TECHNICAL SERVICE BULLETIN

Water Leaking On Right Front Floor During Or After A/C Use - Built On 31-Aug-2018 And Through 02-Feb-2020

20-2170
14 May 2020

This bulletin supersedes 19-2345 . Reason for update: Add Production Fix Date

Figure 2

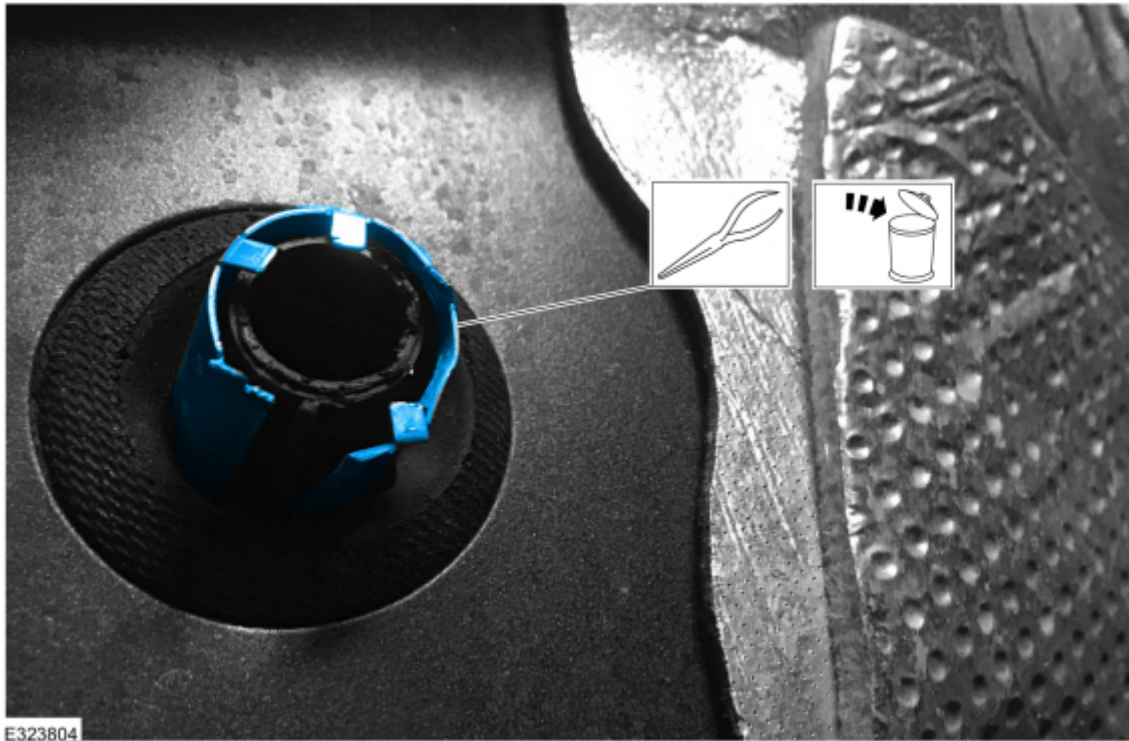
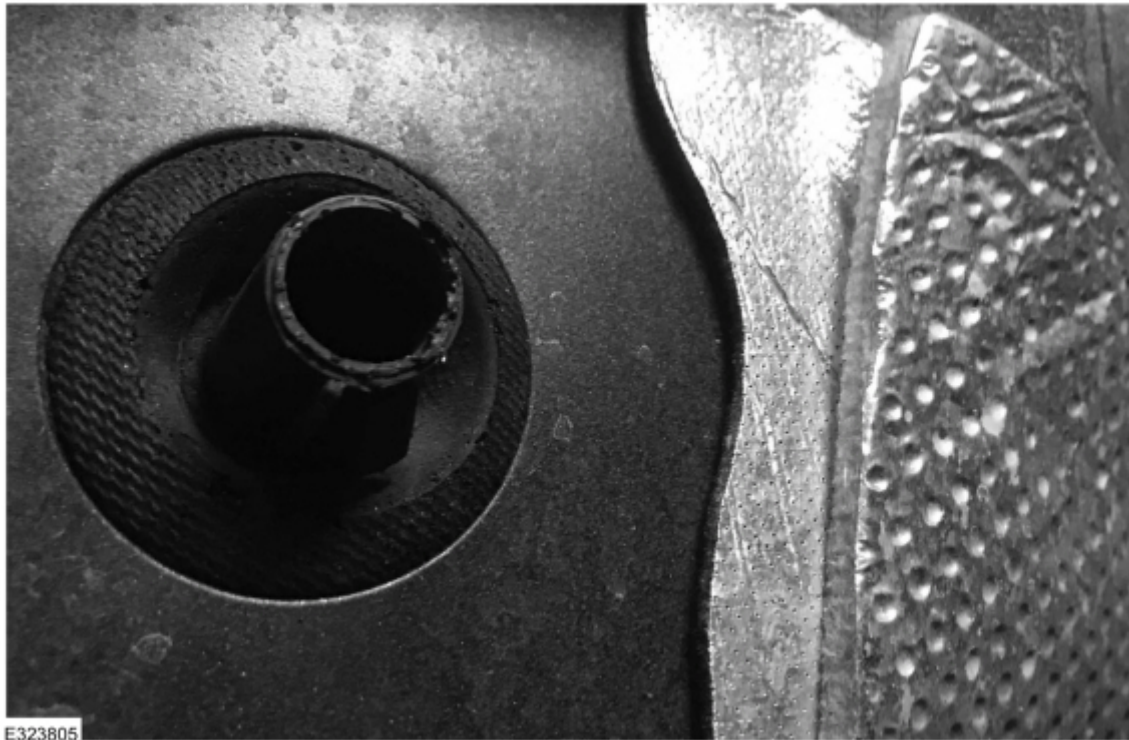
1. Raise the vehicle and remove the right front tire.
2. Remove the right front fender splash shield. Refer to the Workshop Manual (WSM), Section 501-02.
3. Using needle nose pliers or equivalent, remove and discard the metal shield from the evaporator drain tube by bending the tabs away from the tube. (Figures 1-3)

Figure 4

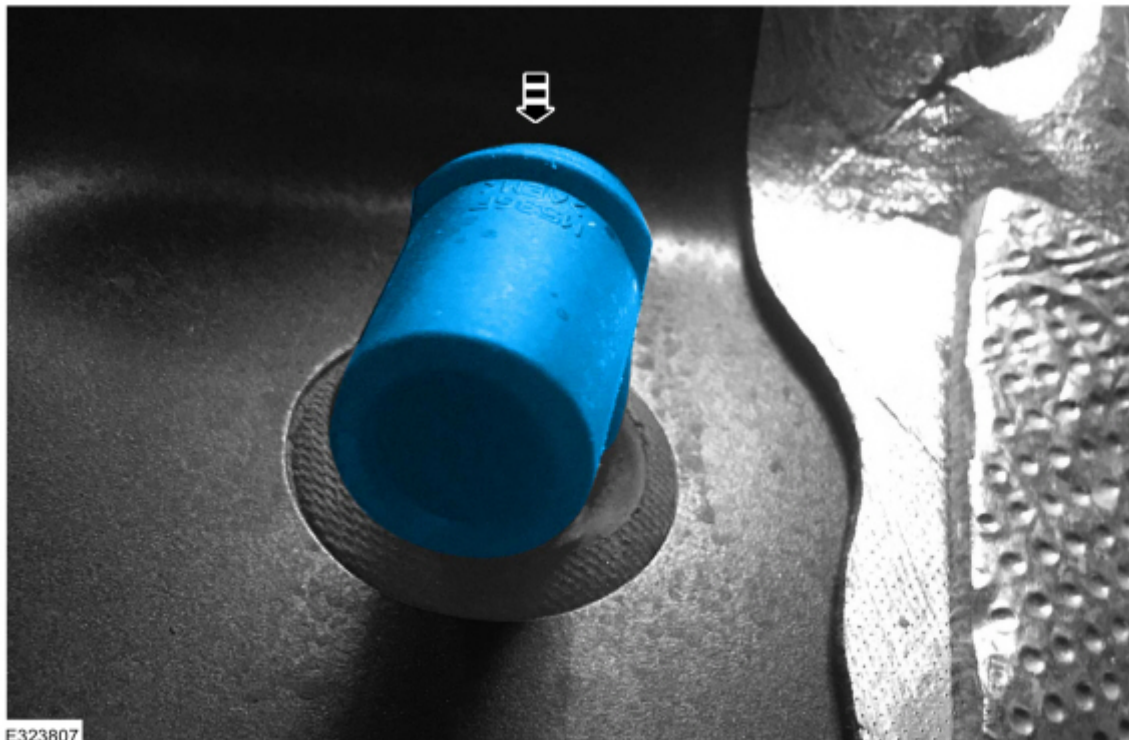
4. Lubricate the inside of the elbow with water. Install the short end of the elbow onto the drain tube. (Figures 4-5)
